**Re: Initial Submission Review – Green Valley Ranch East Site Plan No. 15 - Site Plan and Plat**  
Application Number: **DA-1662-26**  
Case Number(s): 2022-4014-00; 2022-3019-00

On behalf of Oakwood Homes, Aztec Consultants, Dewberry Engineering and Terracina Design, we have reviewed the comments dated March 24, 2022. The following is a response to comments.

SHEET 20 OF 36

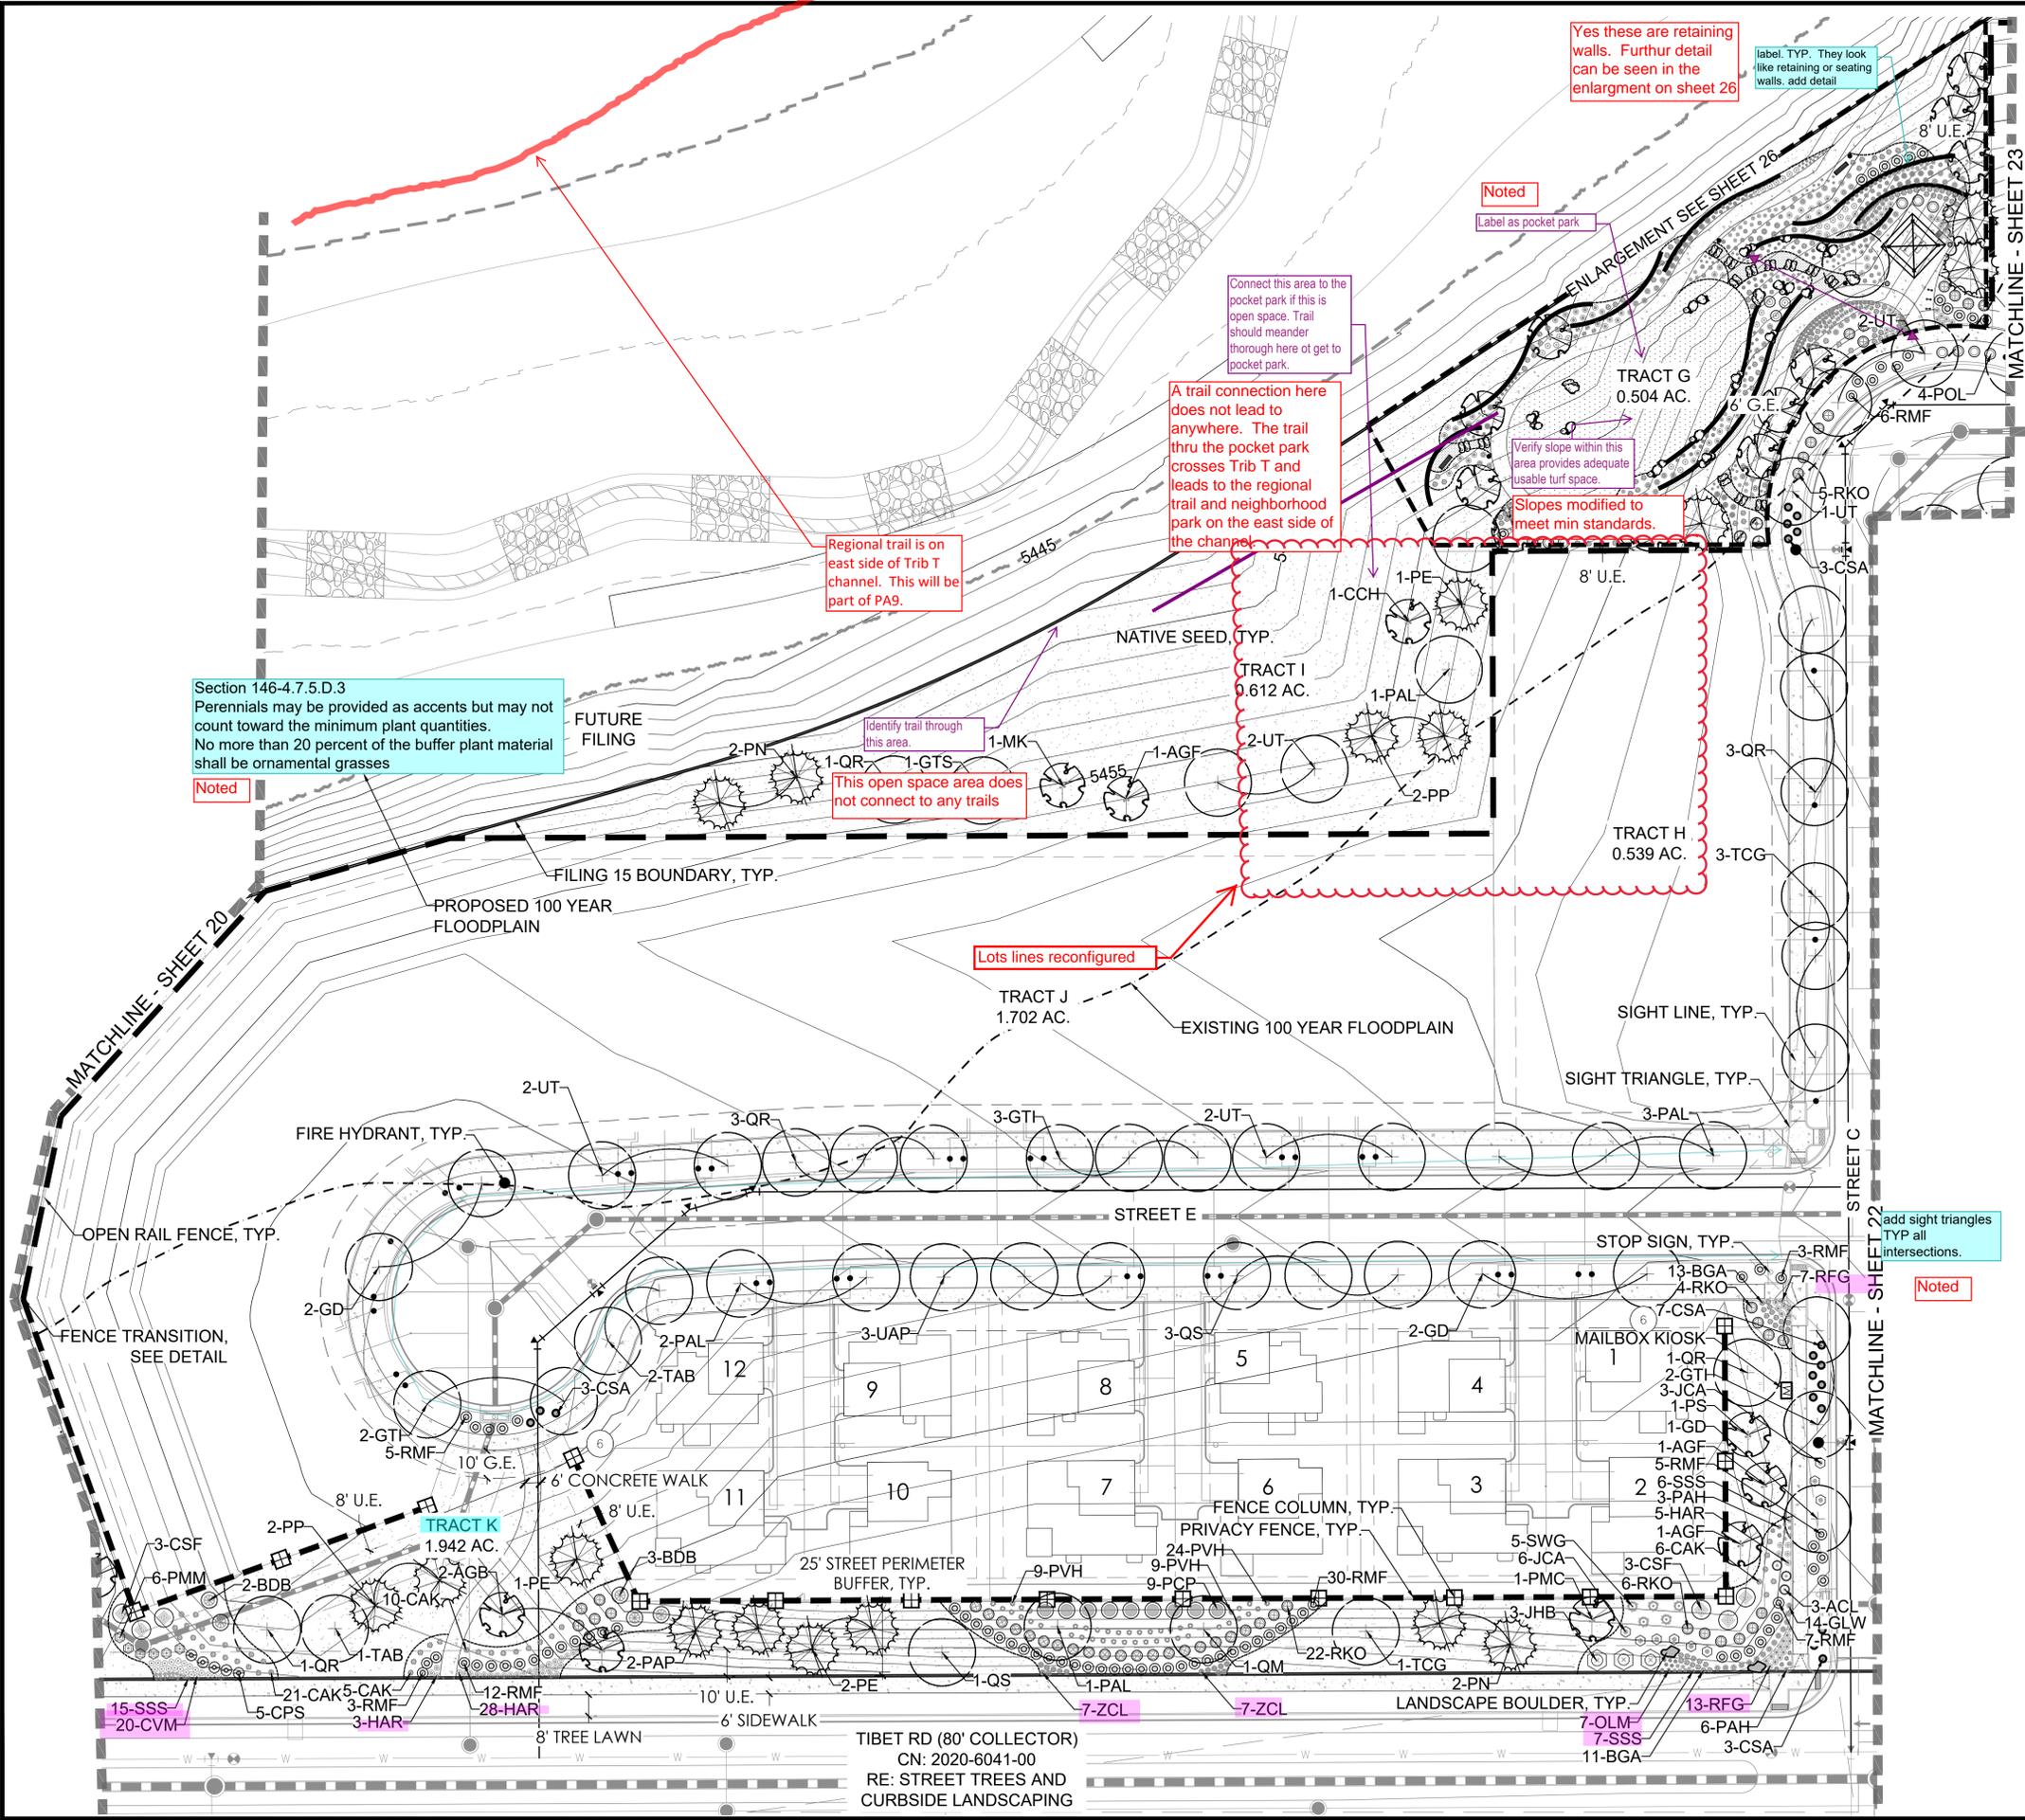
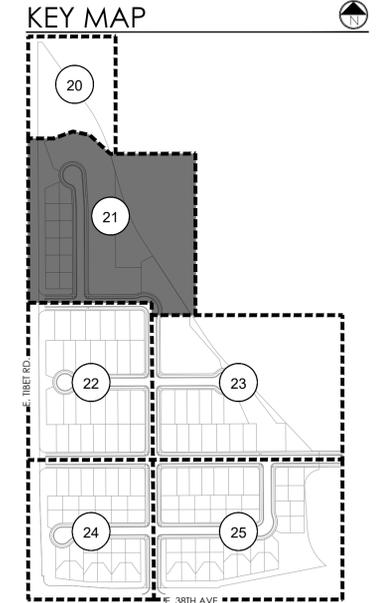
Section 146-4.7.5.D.3  
Perennials may be provided as accents but may not count toward the minimum plant quantities. No more than 20 percent of the buffer plant material shall be ornamental grasses

label. TYP. They look like retaining or seating walls. add detail

Verify slope within this area provides adequate usable turf space.

add sight triangles TYP all intersections.

Yes these are retaining walls. Further detail can be seen in the enlargement on sheet 26

Slopes modified to meet min standards.

SHEET 21 OF 36

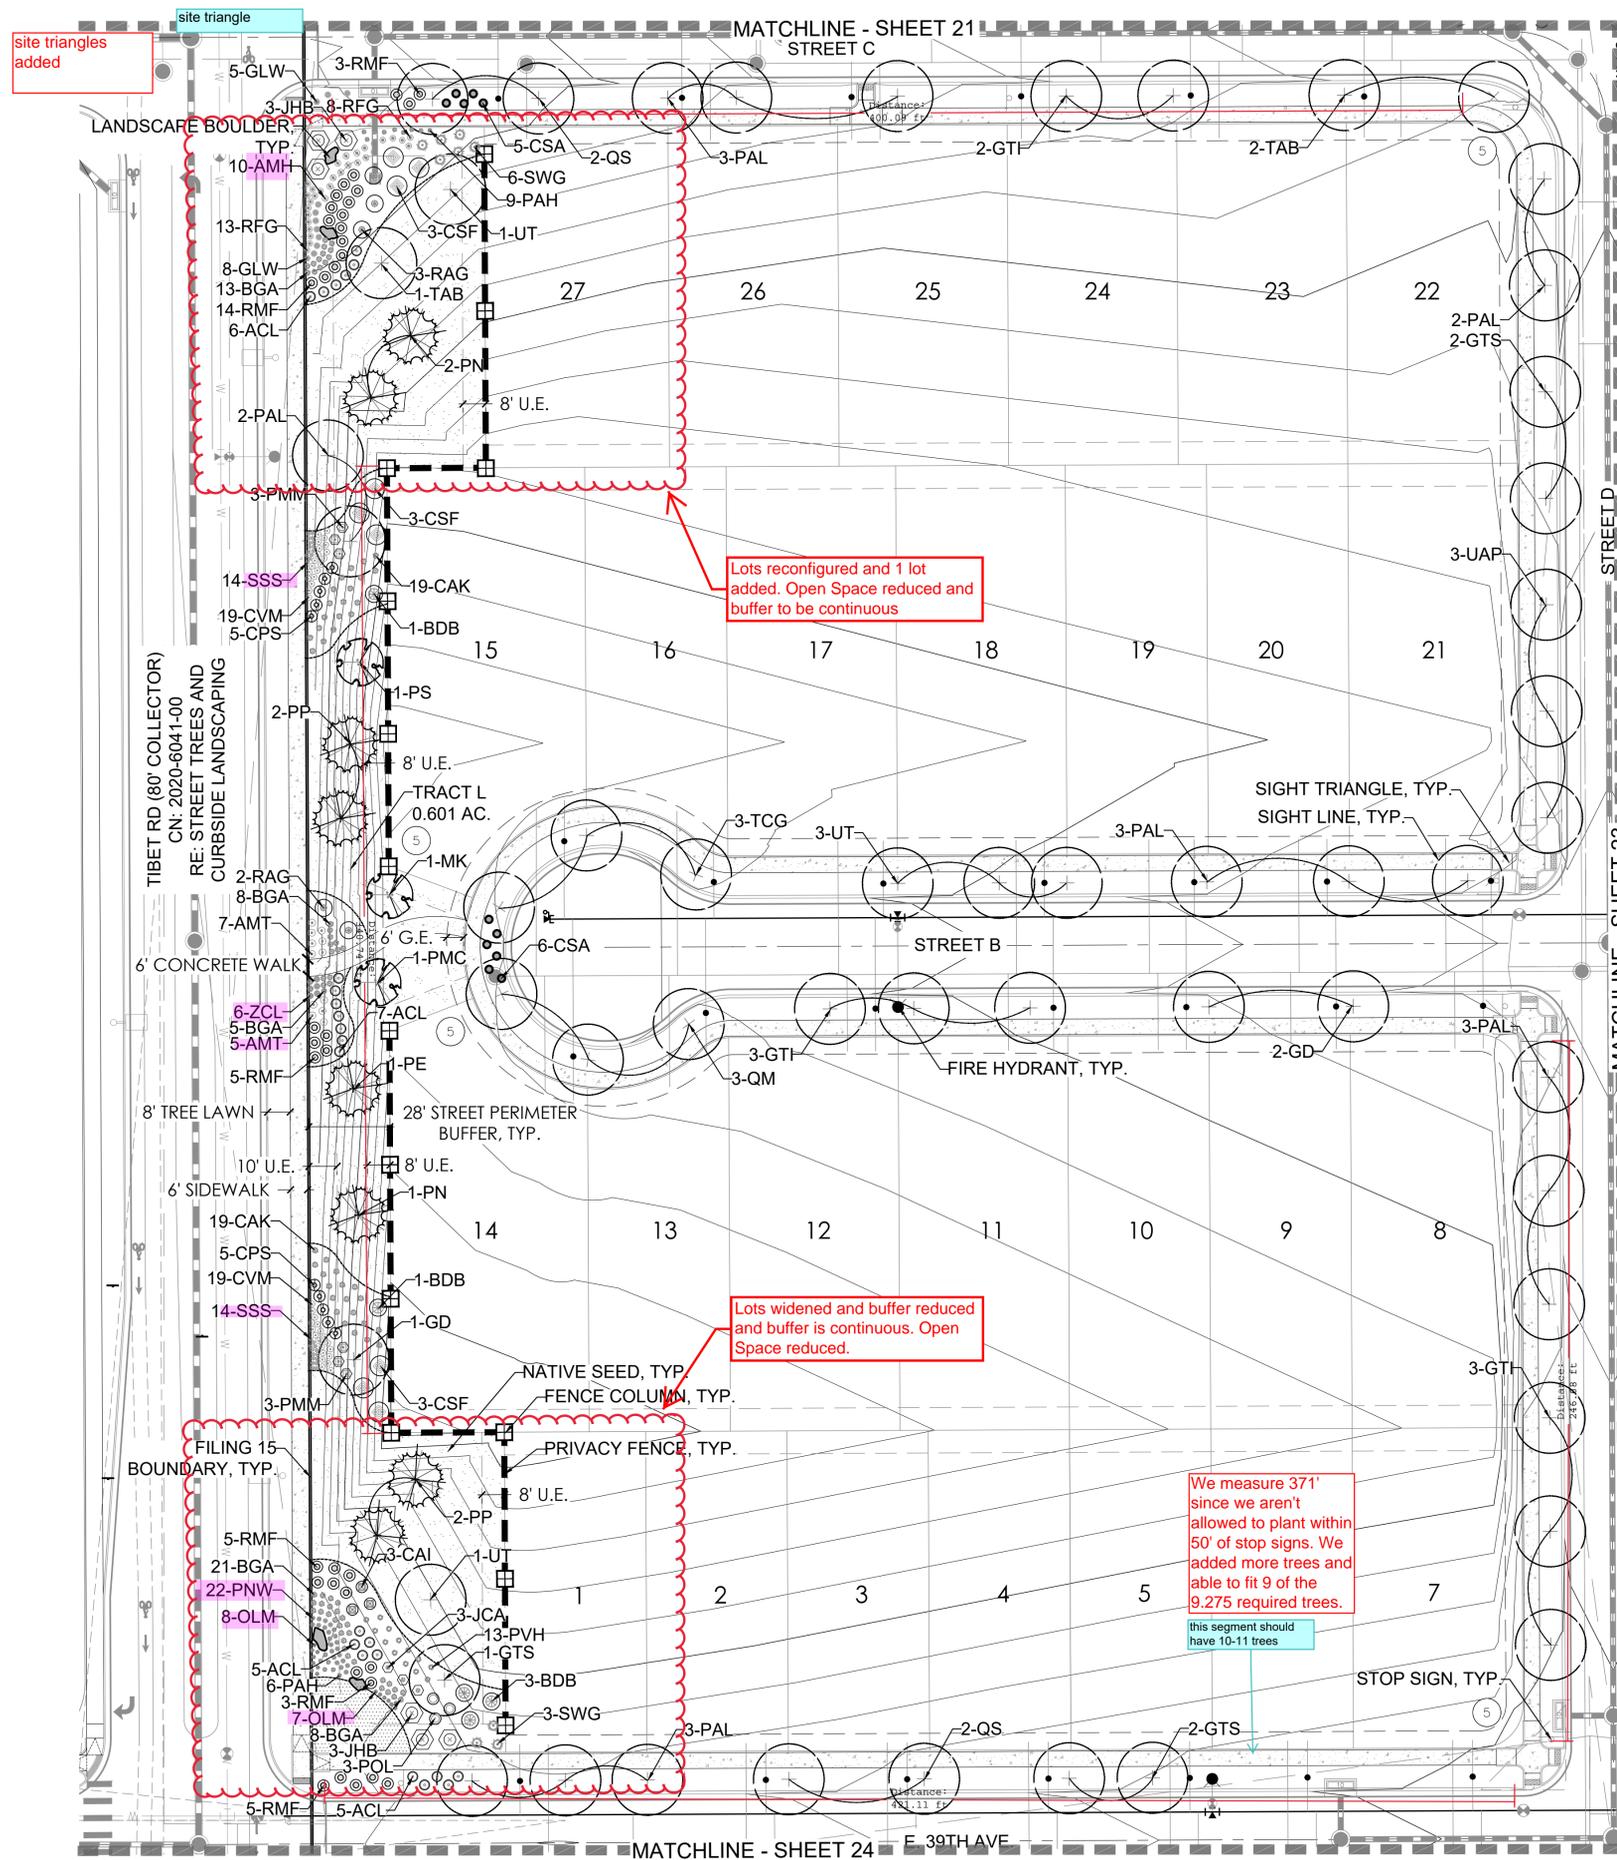
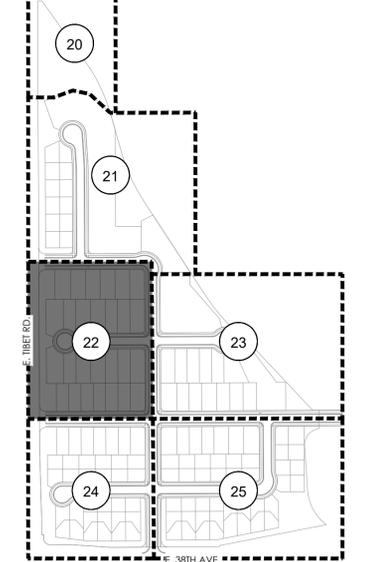
this segment should have 10-11 trees

site triangles added

Lots reconfigured and 1 lot added. Open Space reduced and buffer to be continuous

Lots widened and buffer reduced and buffer is continuous. Open Space reduced.

We measure 371' since we aren't allowed to plant within 50' of stop signs. We added more trees and able to fit 9 of the 9.275 required trees.

**LP.4**

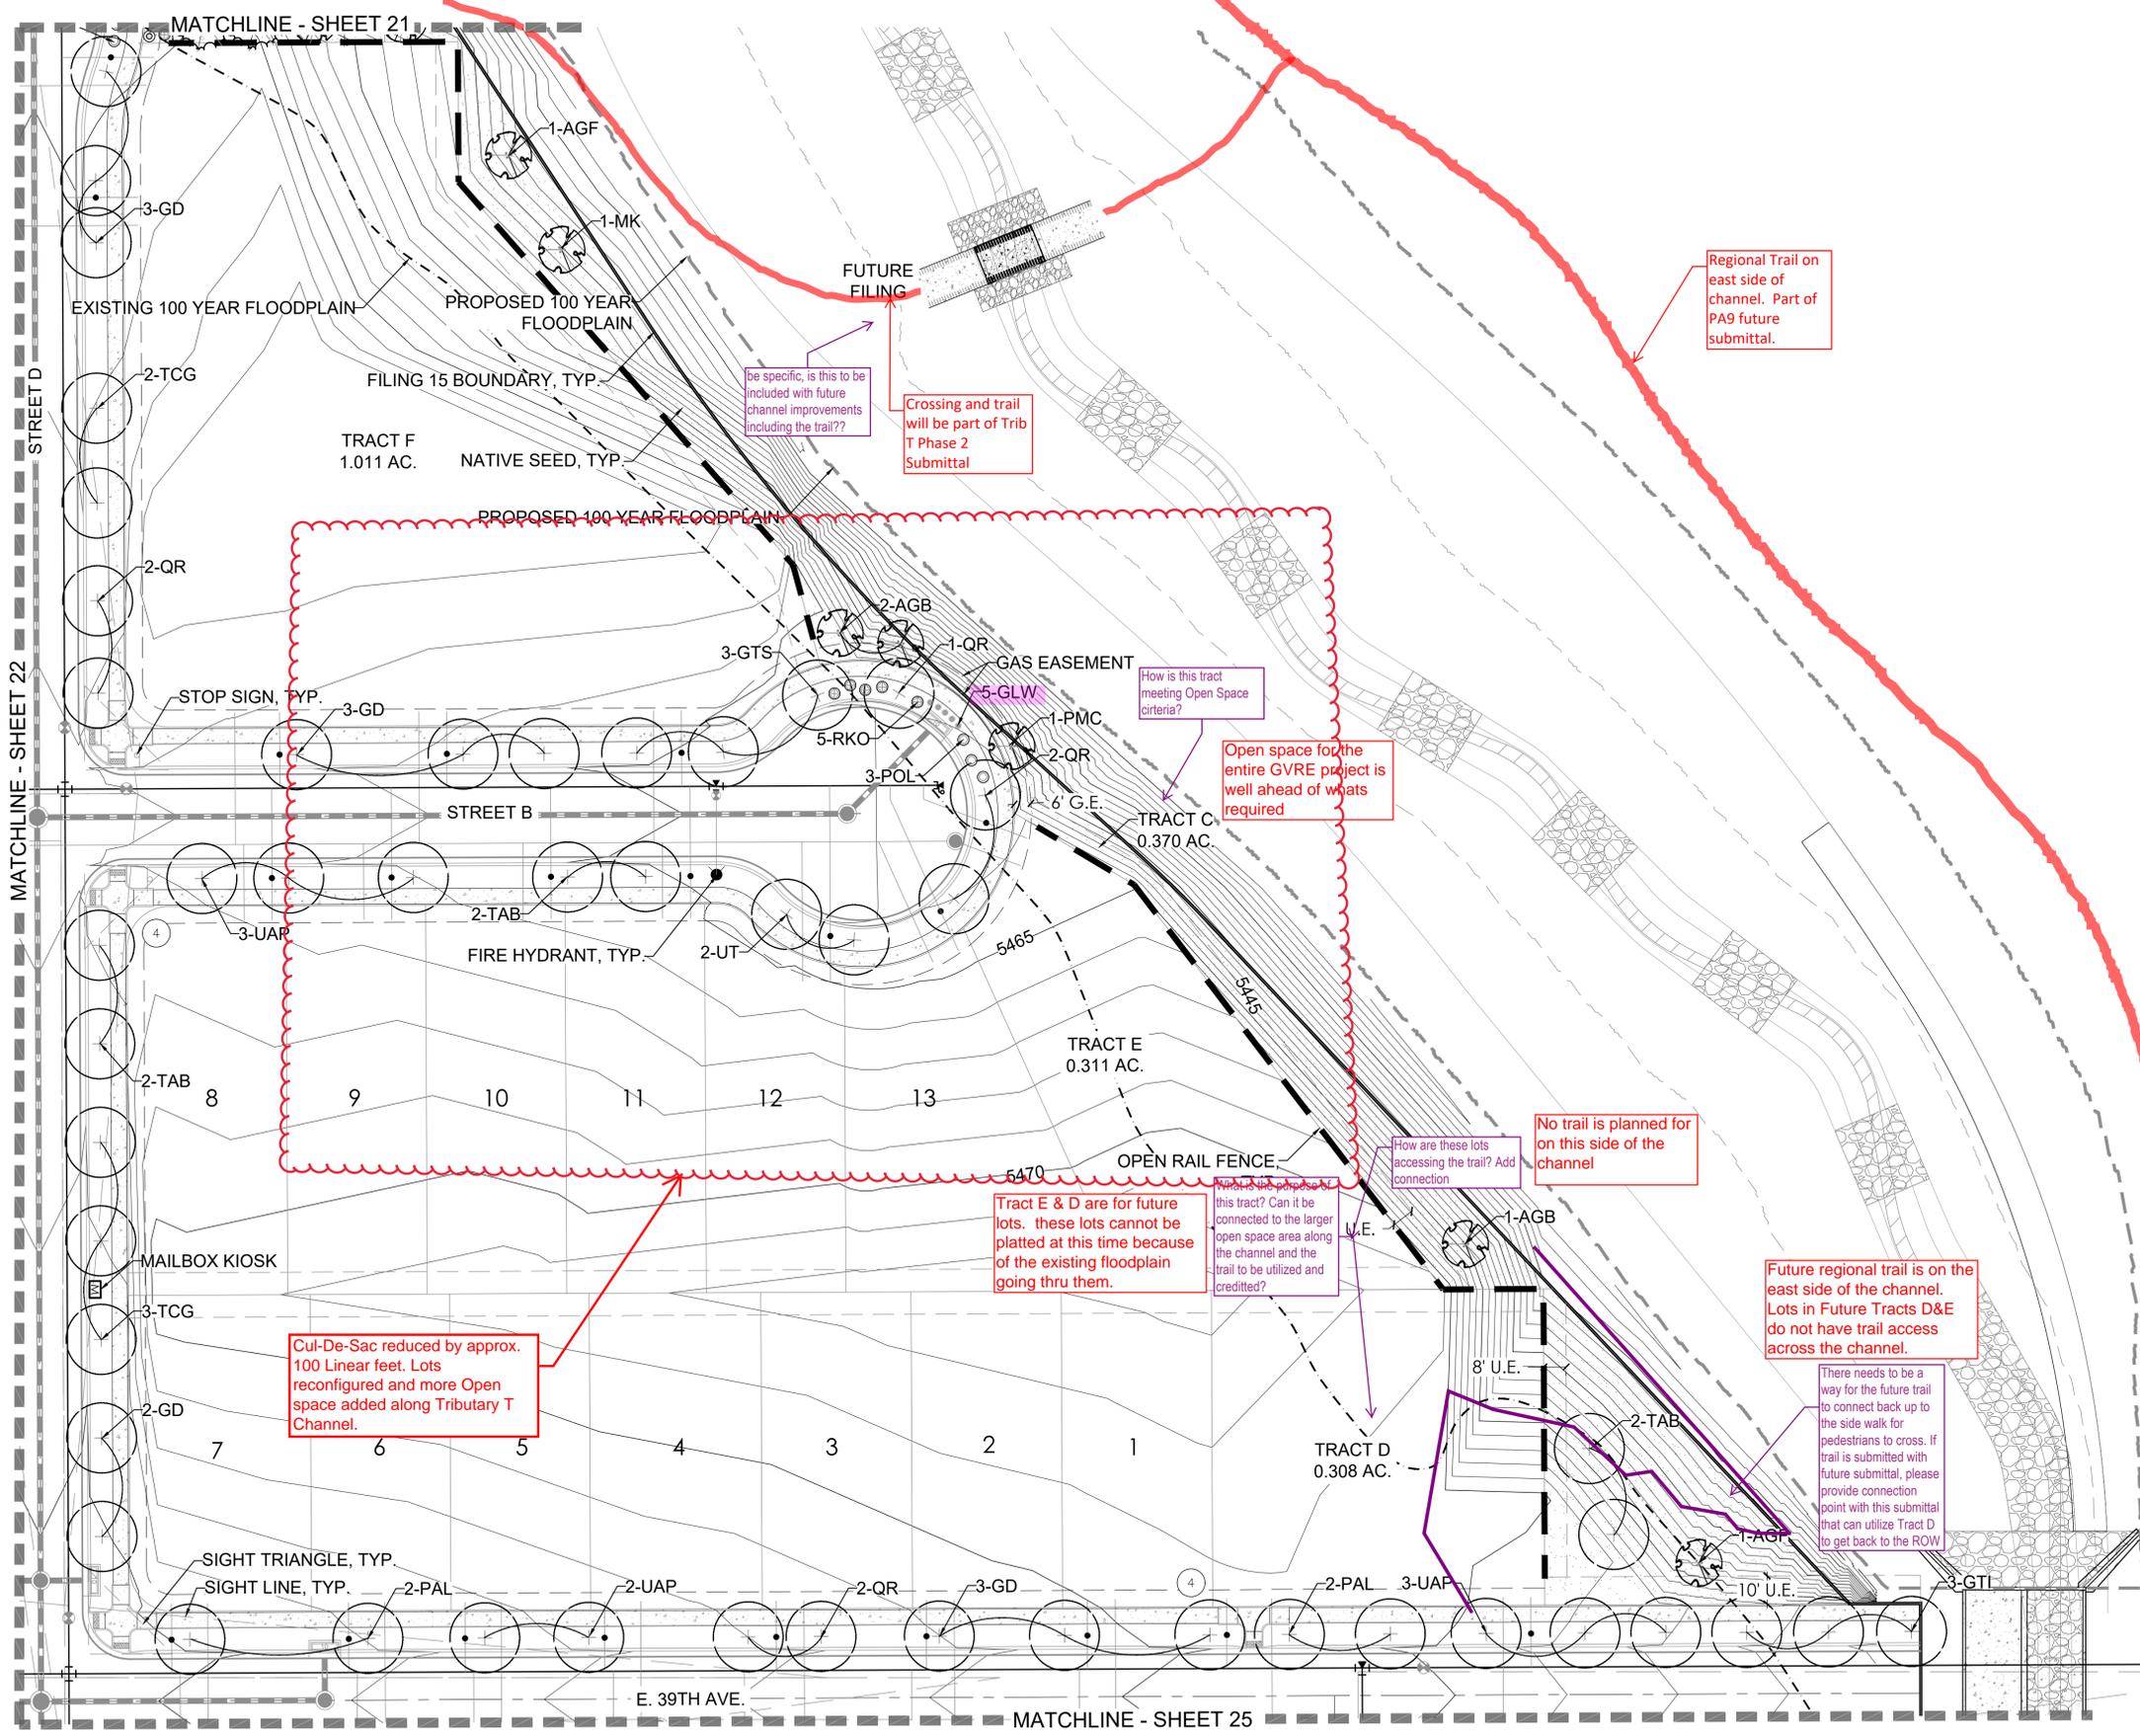
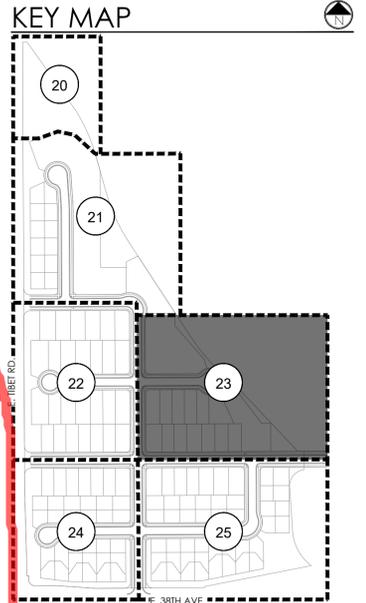
**How are these lots accessing the trail? Add connection**

**There needs to be a way for the future trail to connect back up to the side walk for pedestrians to cross. If trail is submitted with future submittal, please provide connection point with this submittal that can utilize Tract D to get back to the ROW**

**No trail is planned for on this side of the channel**

**Cul-De-Sac reduced by approx. 100 Linear feet. Lots reconfigured and more Open space added along Tributary T Channel.**
